CONVAIR

COMMERCIAL CHANGE PROPOSAL

SPEC NO.: ZD- 22-002

MODEL: 22-1 (Convair "880")

Figure 3.20-5

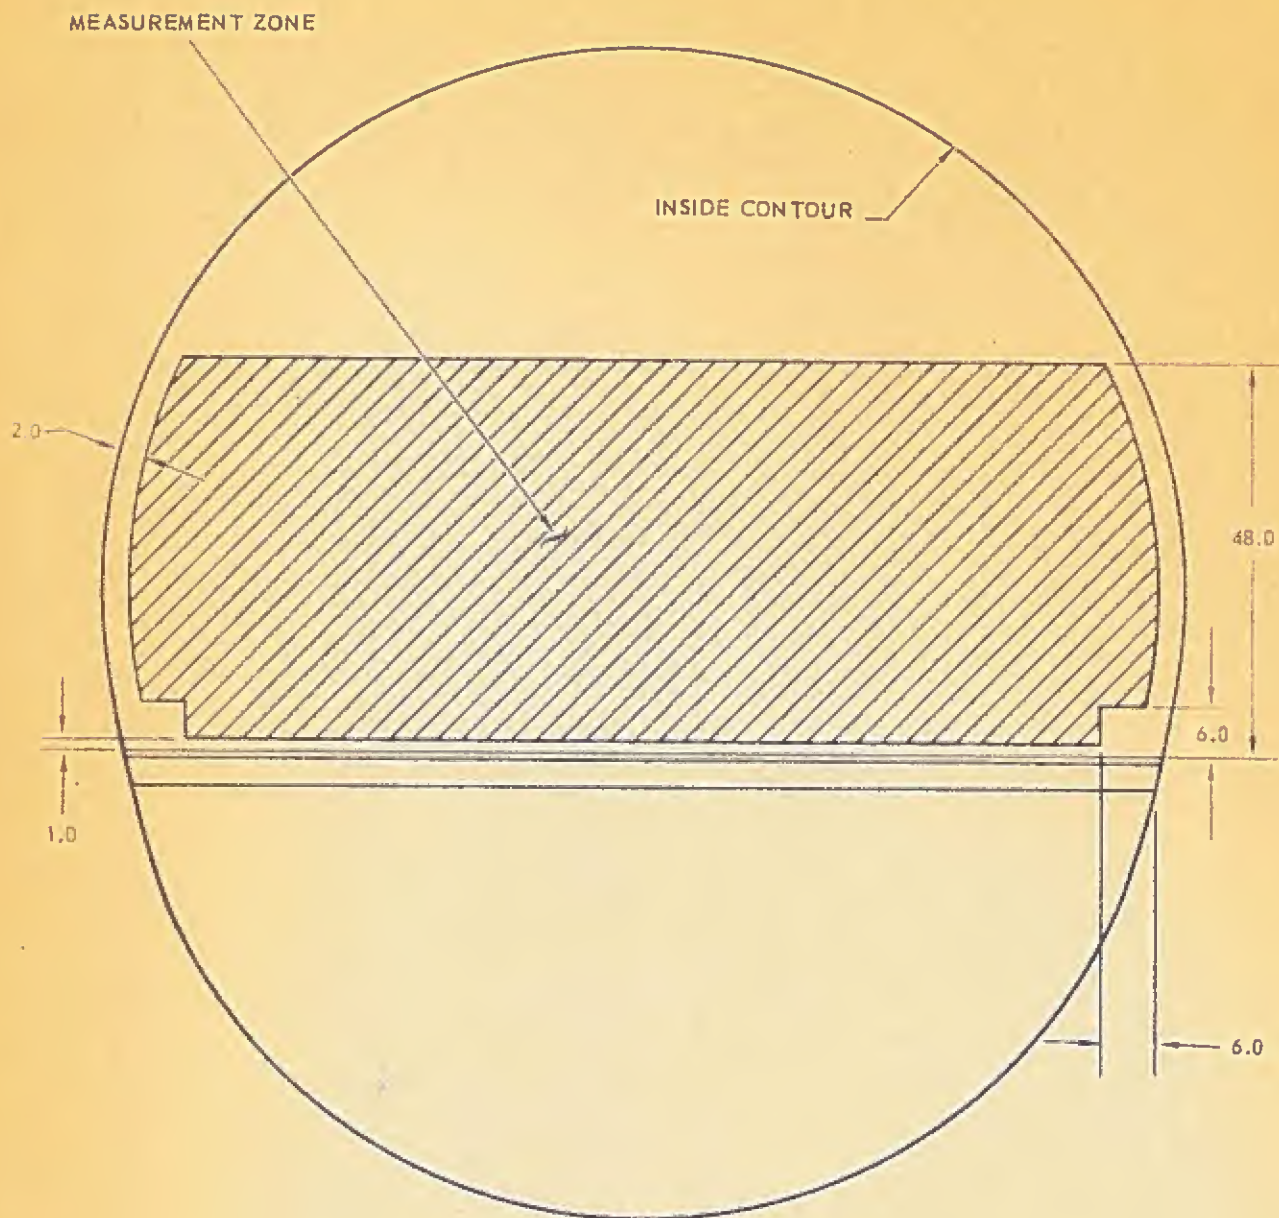
In the second sentence, change "Figure 3.19-11" to "Figure 3.20-5"

Enclosure: (A) One copy Figure 3.20-5 - TEMPERATURE MEASUREMENT
PLANE (To be incorporated into Specification on
Customer approval thereof)
